FINAL ENVIRONMENTAL ASSESSMENT

**Endangered Fish Passage Project at the
Grand Valley Project Diversion Dam**

**Fish Screen in the
Government Highline Canal**

March 2003

Figure 5-Concrete Fish Passage Conceptual Drawing

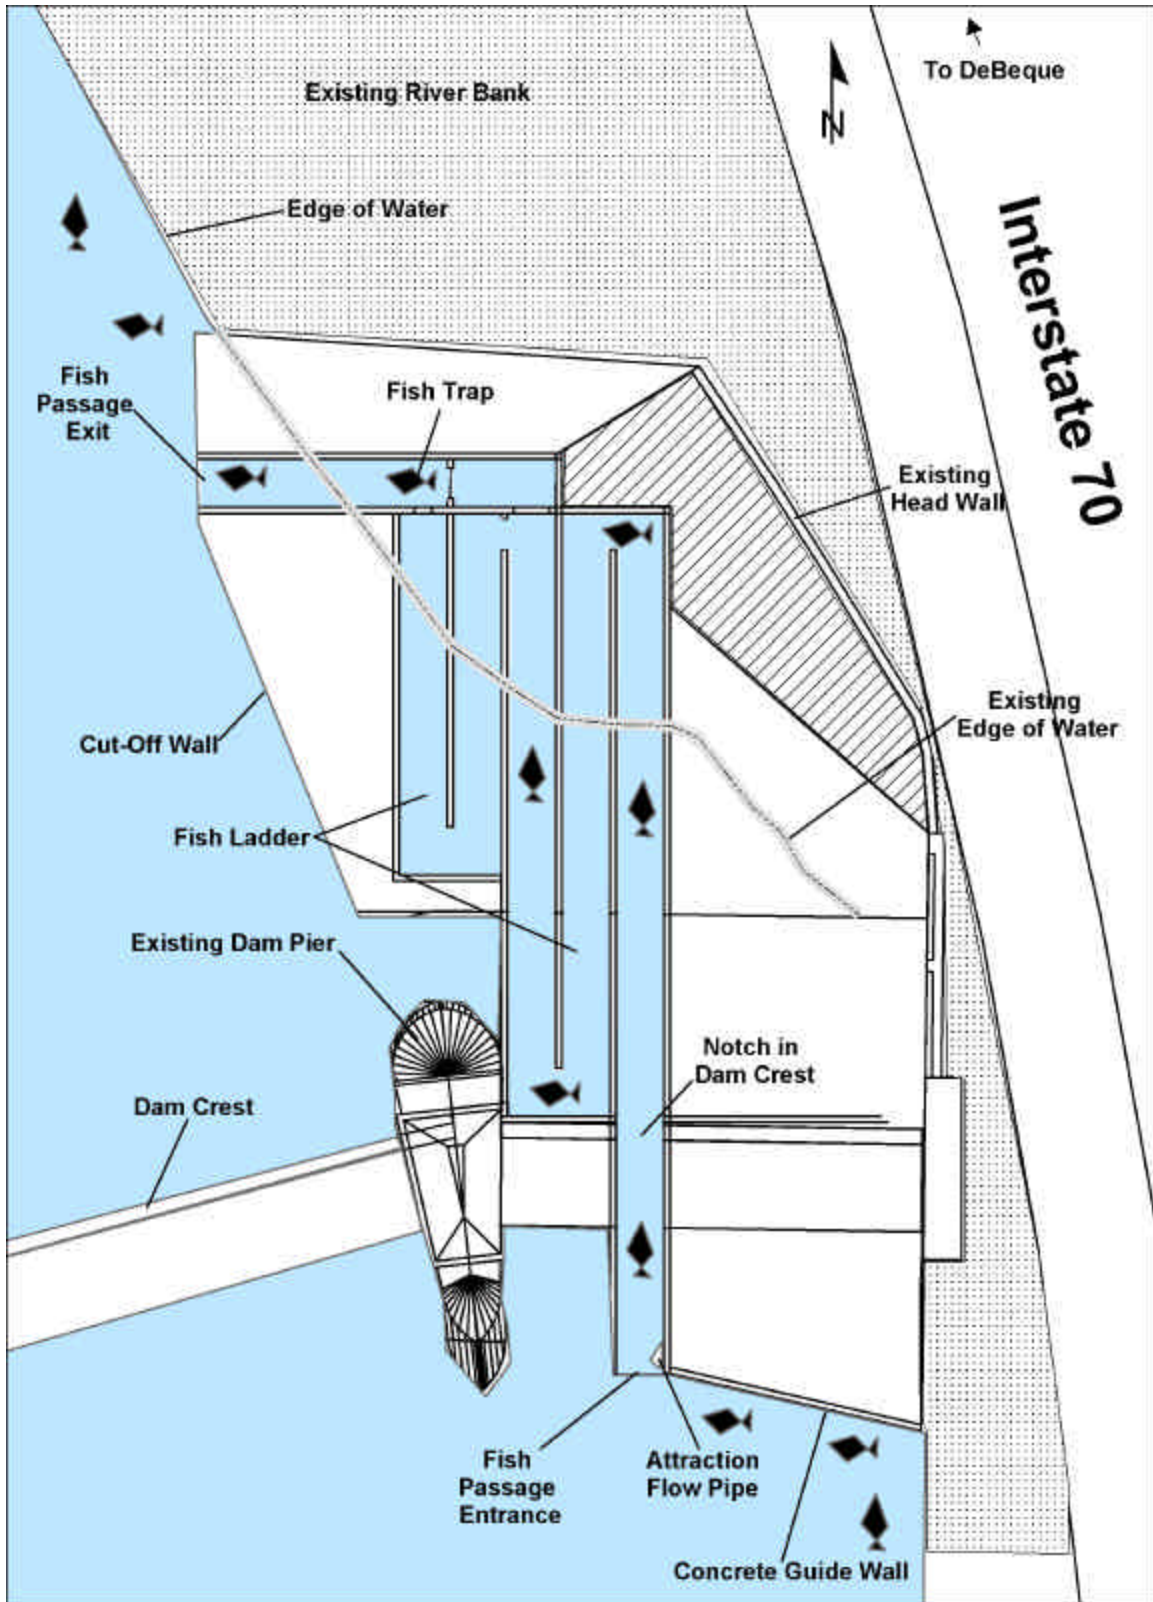
Comment 1: The Department agrees with the Rock Fish Passage as the preferred alternative, for all the reasons stated on page 11 of the Environmental Assessment. In particular, this alternative has the biological benefit of allowing the fish to re-enter the river at a point high enough upstream from the dam to accomplish their passage while reducing the likelihood of fish falling back over the dam.

Response 1: Discussion of selection of the preferred alternative is discussed in the EA. The concrete fish passage was moved to extend further upstream to address concerns with and reduce the incidence of “fish fall-back” over the dam.

Figure 8-Government Highline Canal Fish Screen Conceptual Drawing

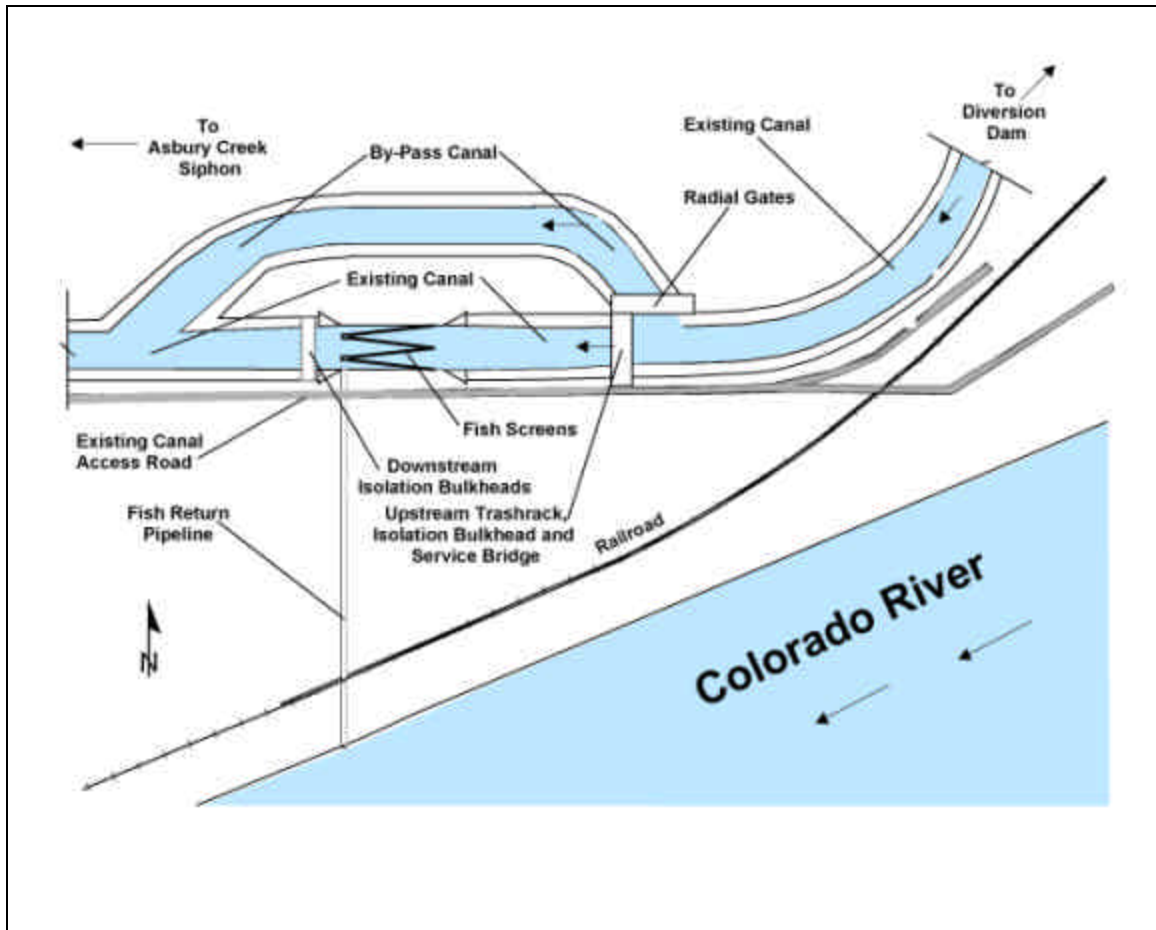
Comment 7. Page 14, Construction: There are no conceptual drawings for the construction of the fish screen, only locations. We would like to know what the screen and return to river look like. Are there any right-of-way issues with the railroad given that this is one of the primary routes? Are there any return design considerations between the canal and river that should be identified (e.g. slope, amount of fall or distance)?

Response 7. Additional detail was added to both the Design and Construction Sections regarding the fish screen in the final EA. A conceptual drawing of the fish screen was also added to the final EA.
